SUBJECT: PLANS AND PROPOSAL ADDENDUMS

PROJECT: F 2B24(277)

CONTROL: 0033-05-089

LETTING: 07/09/2024

SYSTEM SHOWN - ABSORB-M TL-3

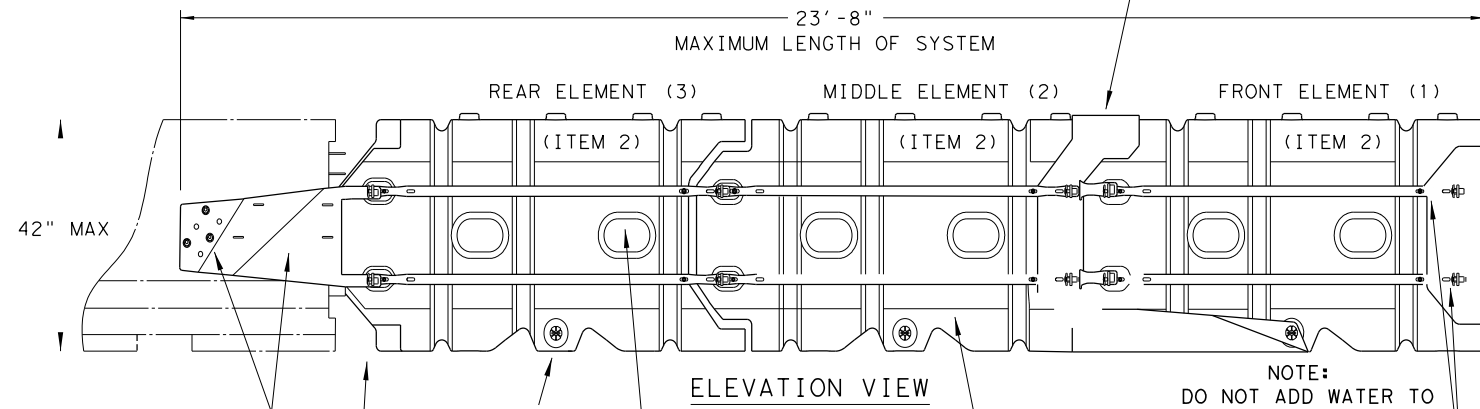
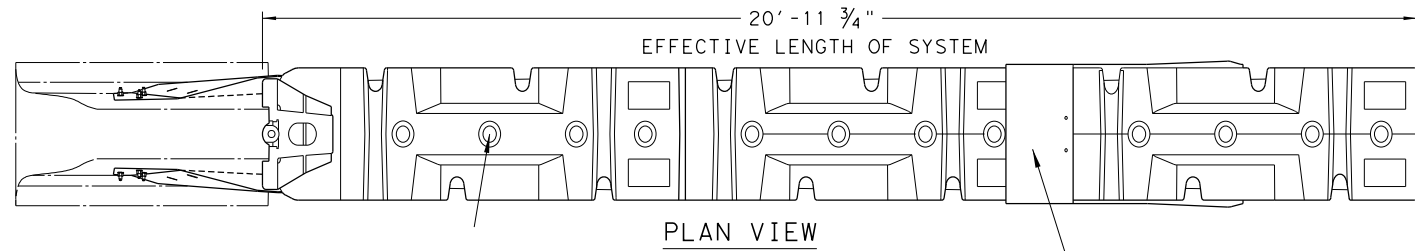
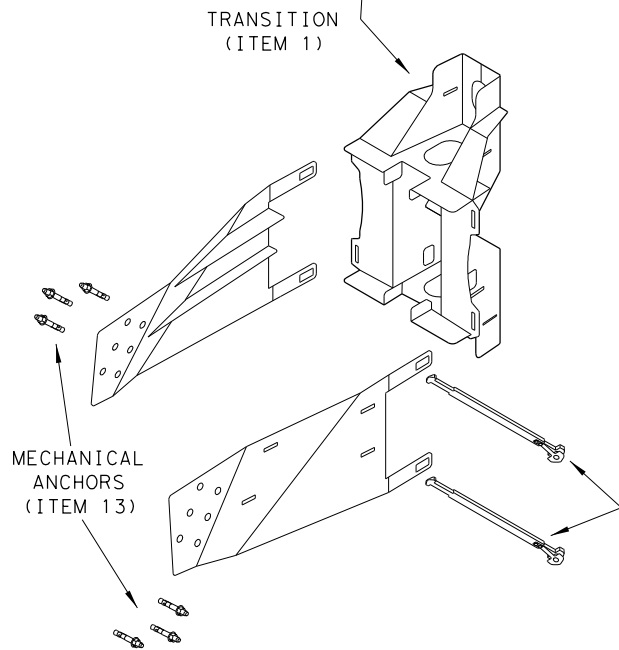
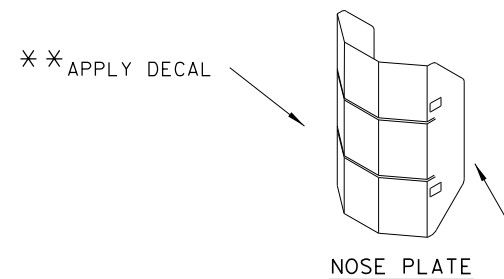
ADDED SHEETS: 148A

| SHEET | DESCRIPTION |
|----------------------------------|--|
| 148A | # ABSORB (M) - 19 (MASH TL-3 REQUIRED) |

US 83
CULVERT LAYOUT G-1
FM 3034 STA 10+60.93

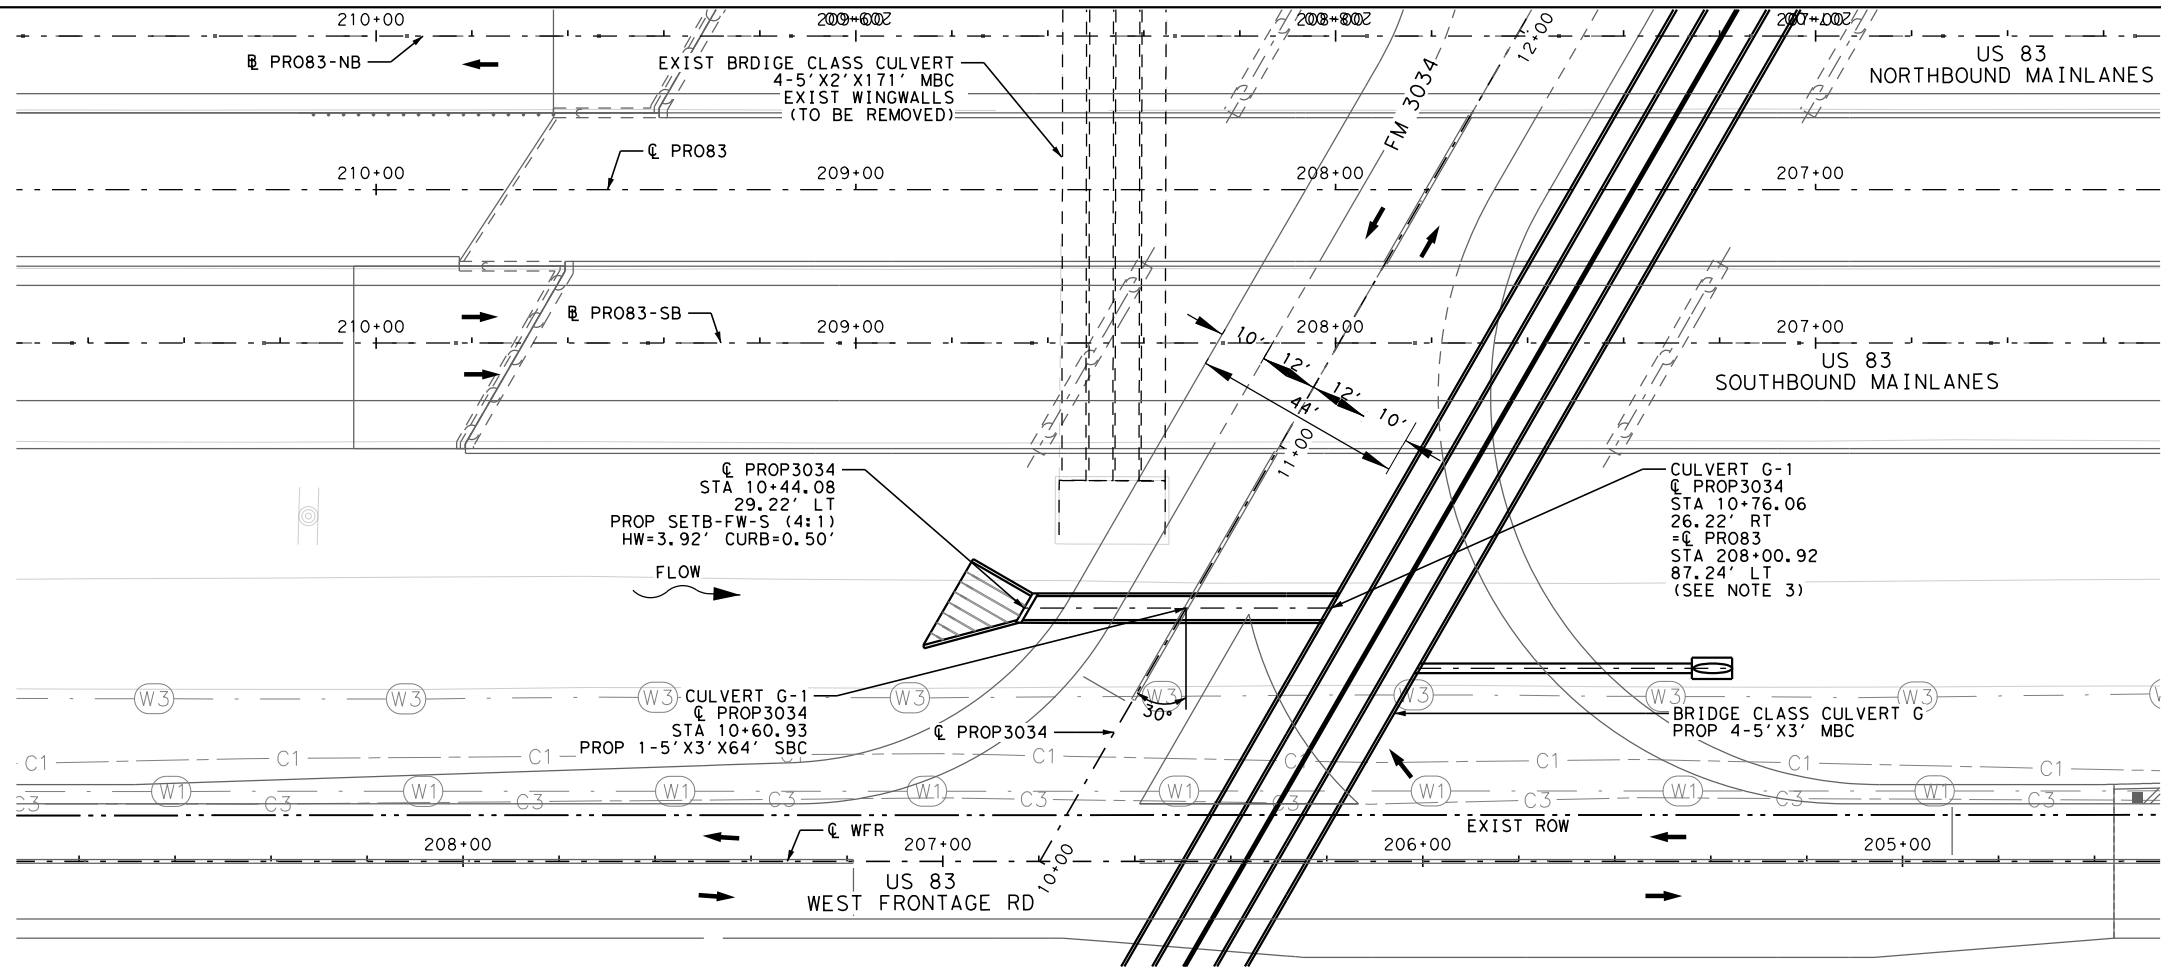
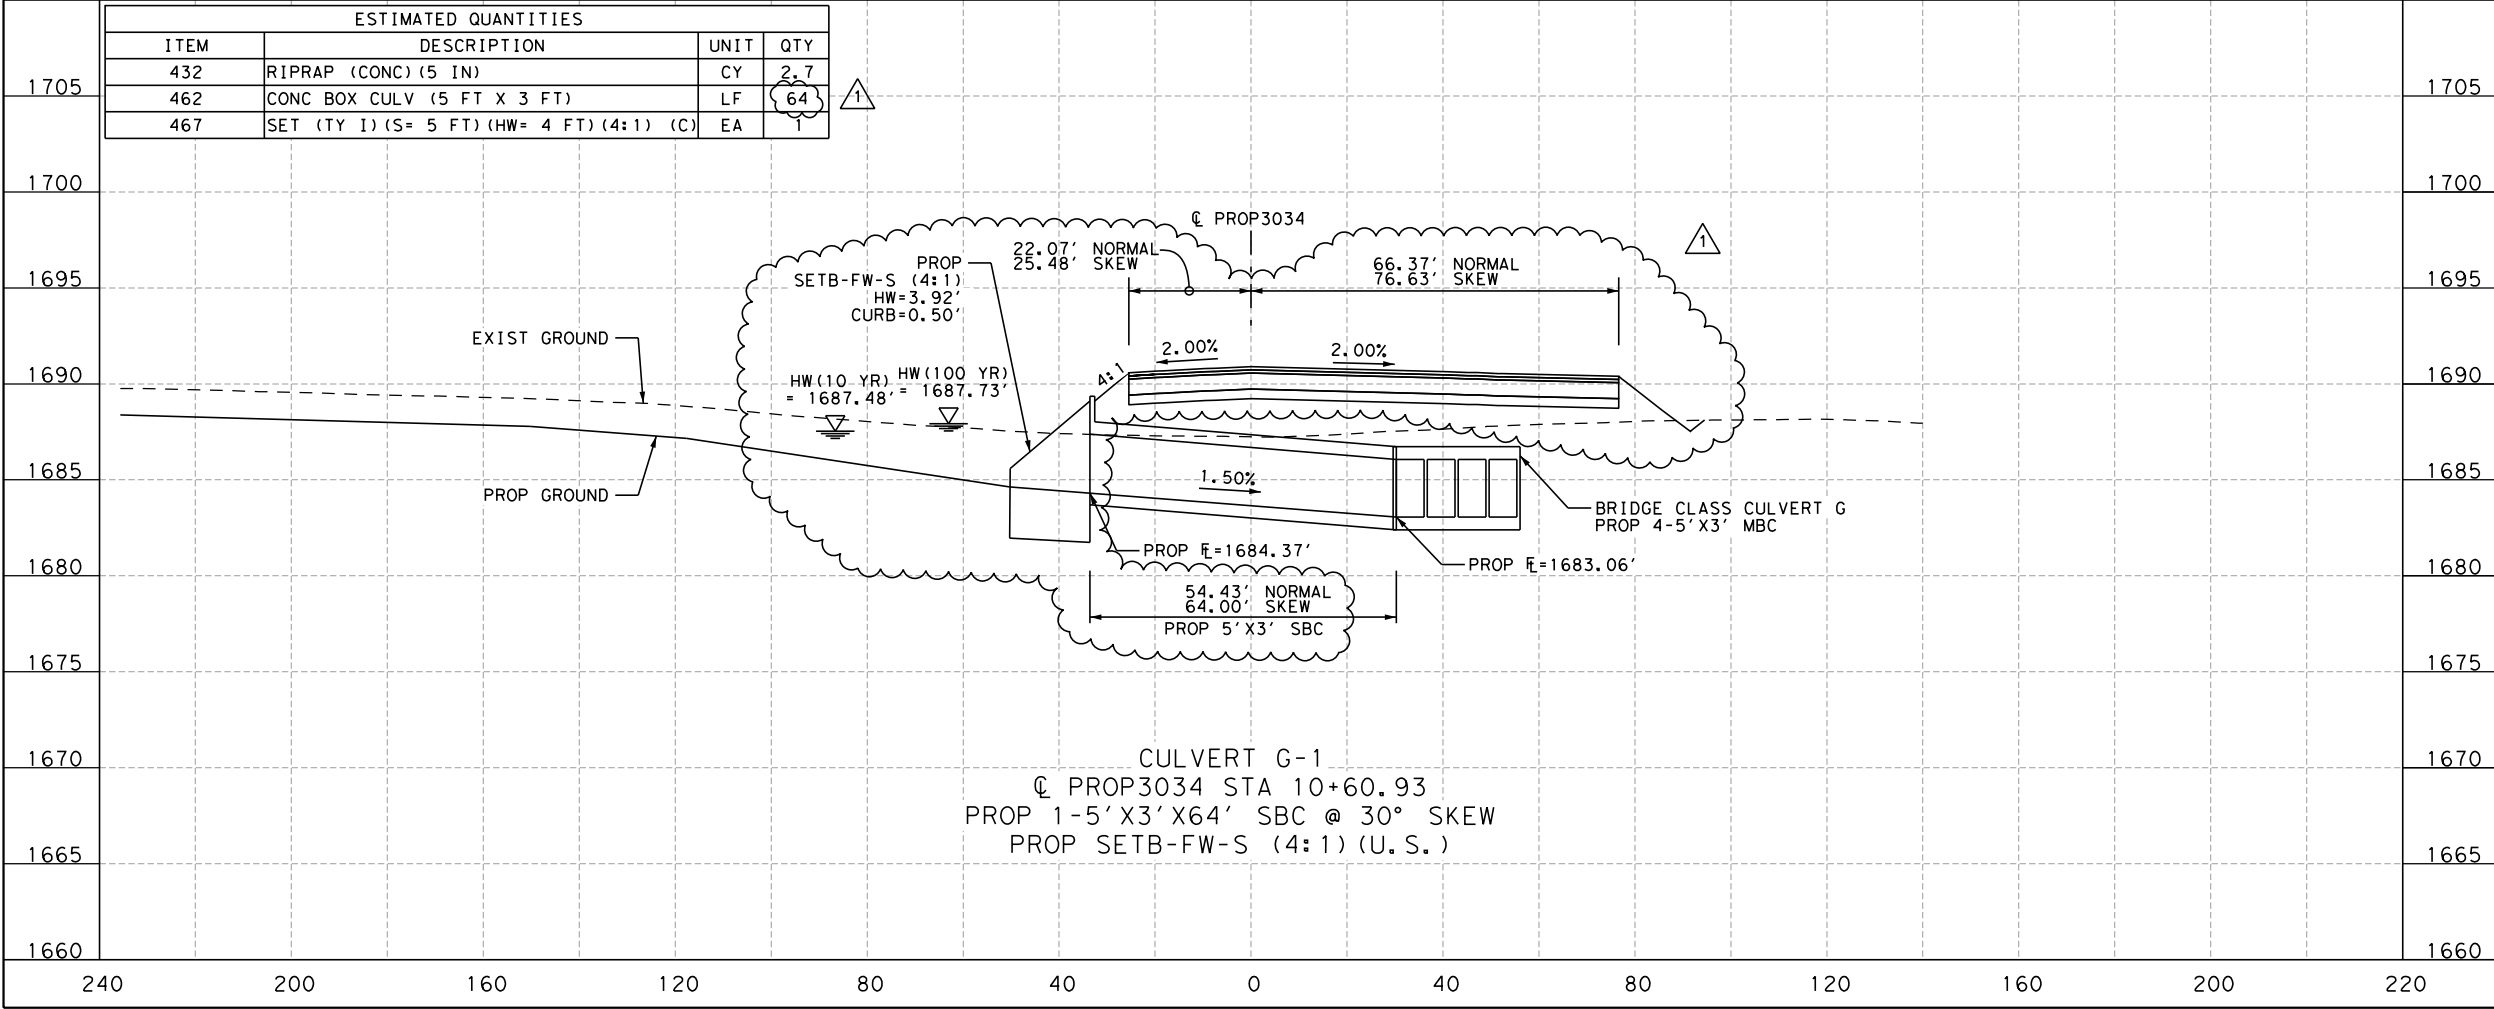
REPLACED SHEETS: 002,028,034,035,036,037,038,051,058,270,280
